Architect's Supplemental Instructions

Architect's ASI No: 041

Project:
Webster University
Interdisciplinary Science
Building

Date Issued: 12/13/2016

T0101.A

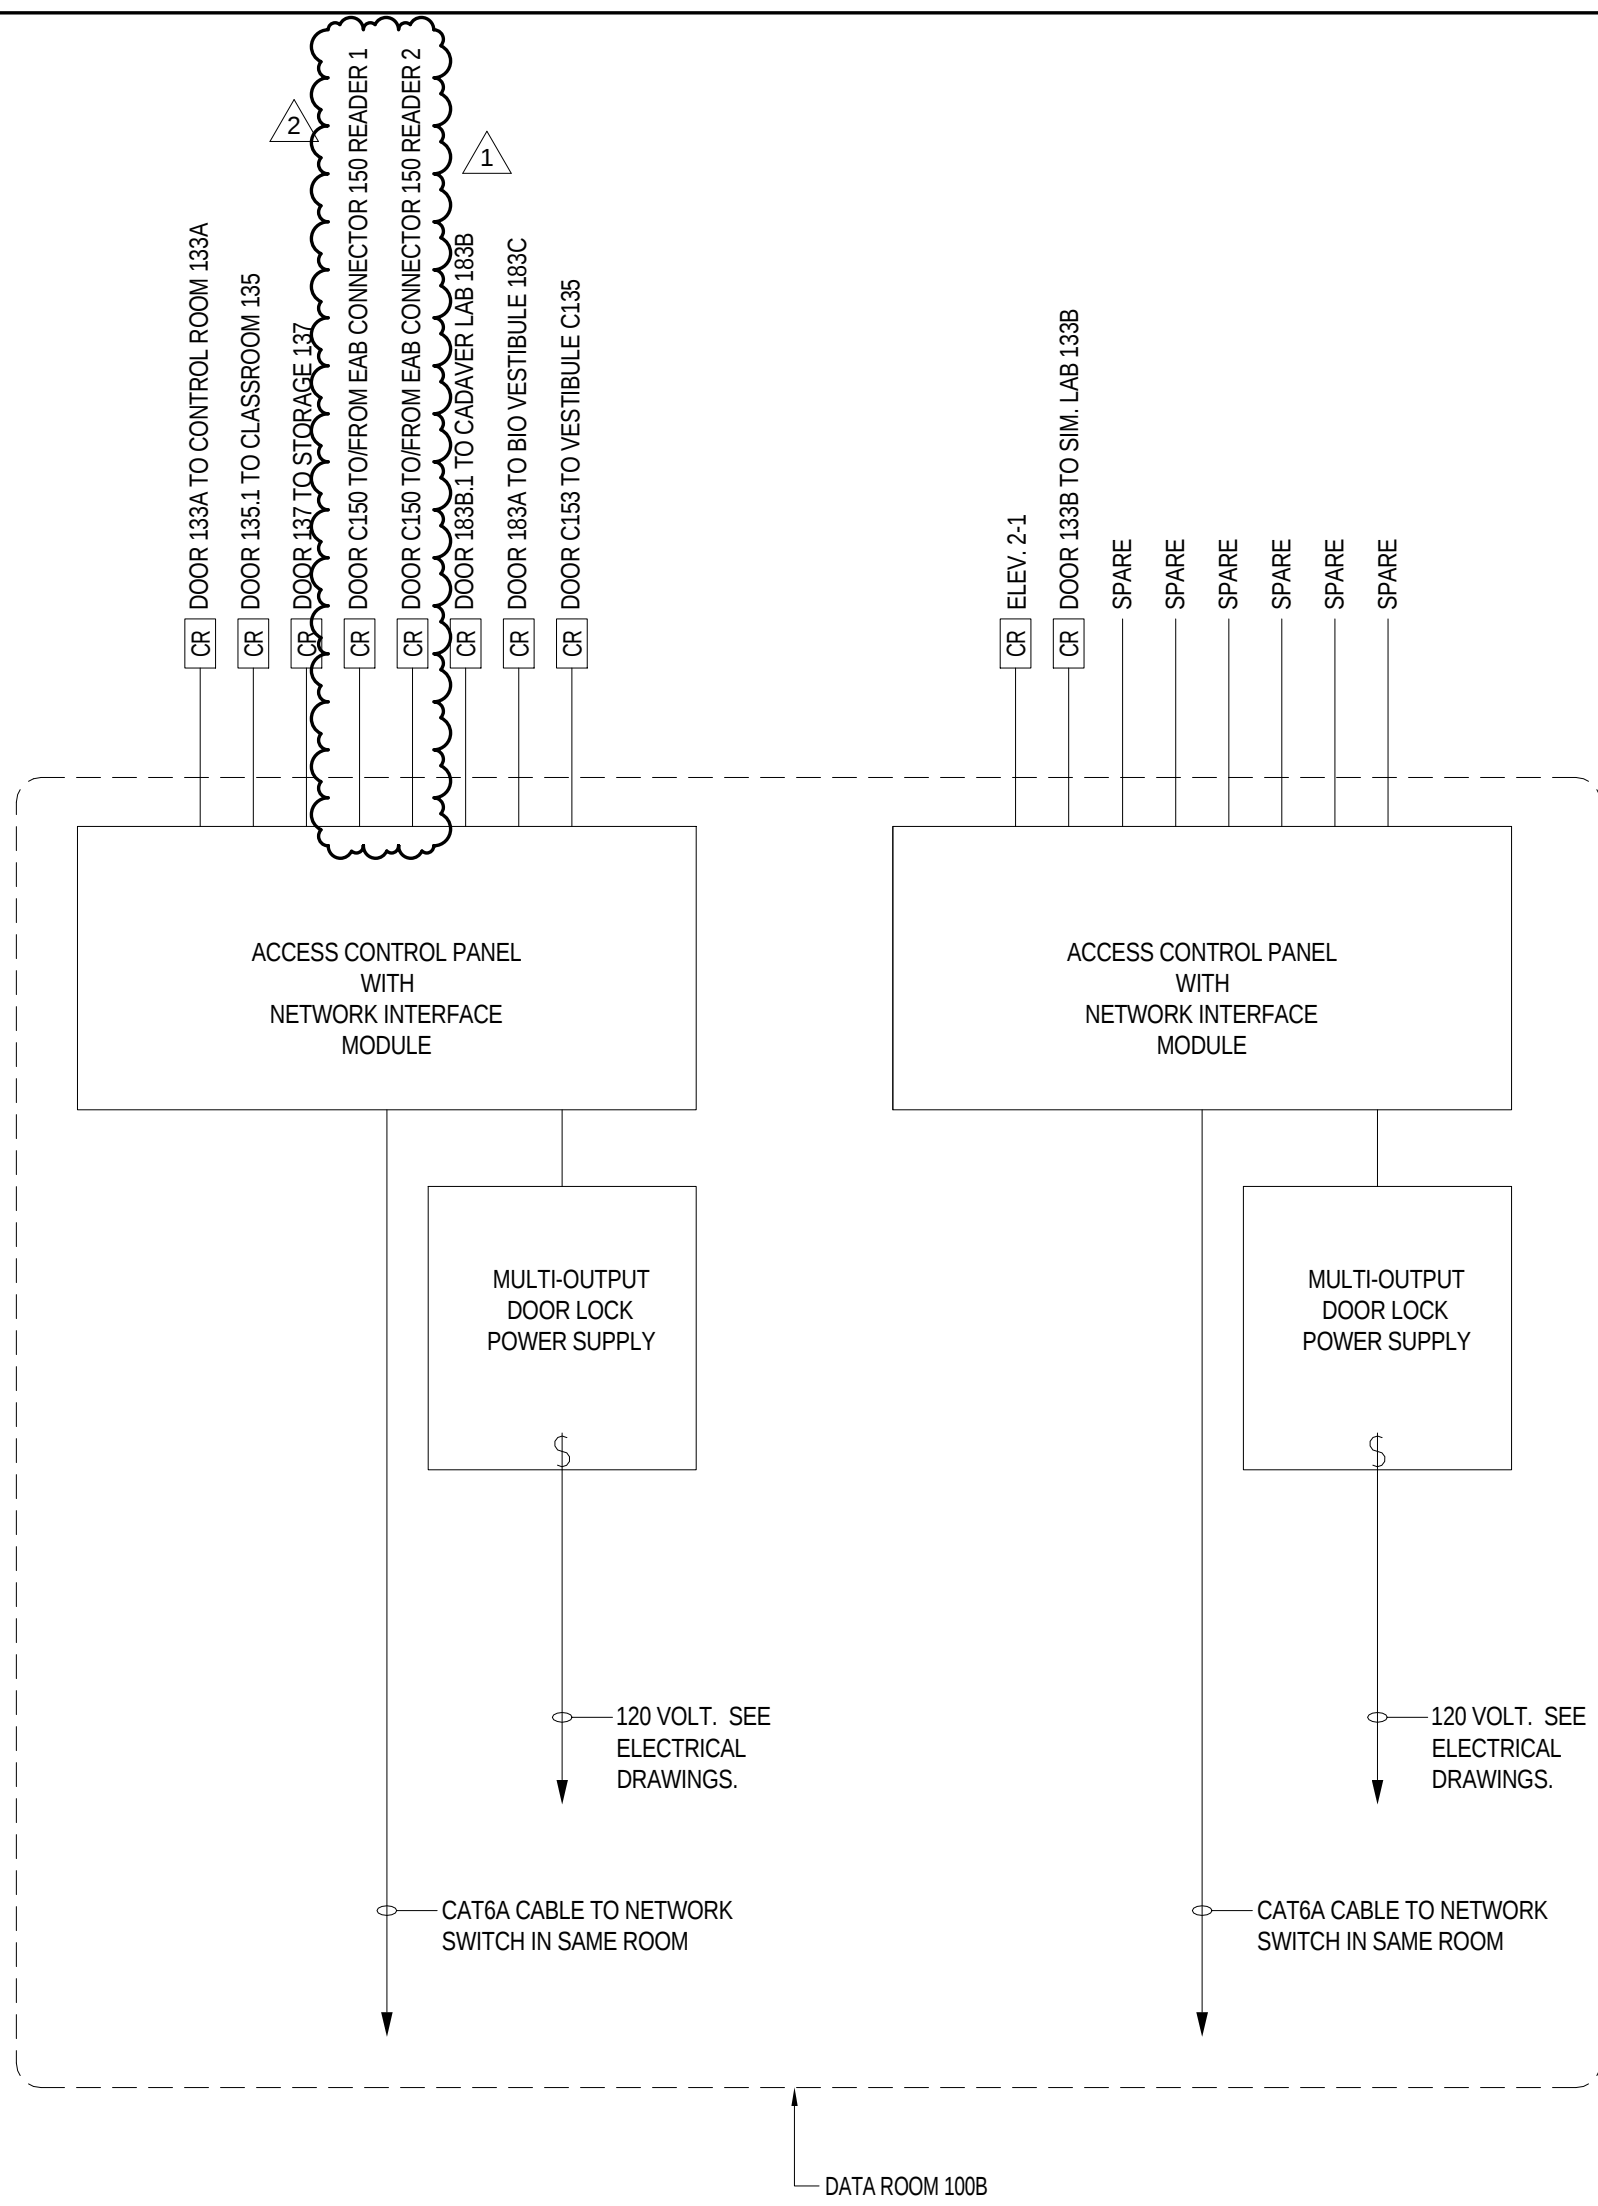
1. T0101.A – LEVEL 01 FLOOR PLAN – AREA B
 - A. Relocated access control equipment from door 170 to door 150.
2. T0803 – ACCESS CONTROL BLOCK DIAGRAMS
 - A. Revised Level 1 block diagram
3. T0804 – ACCESS CONTROL DETAILS
 - A. Revised Door Interface Boxes
 - B. Revised Access Control System cable
 - C. Revised General Notes
 - D. Revised Responsibility matrix
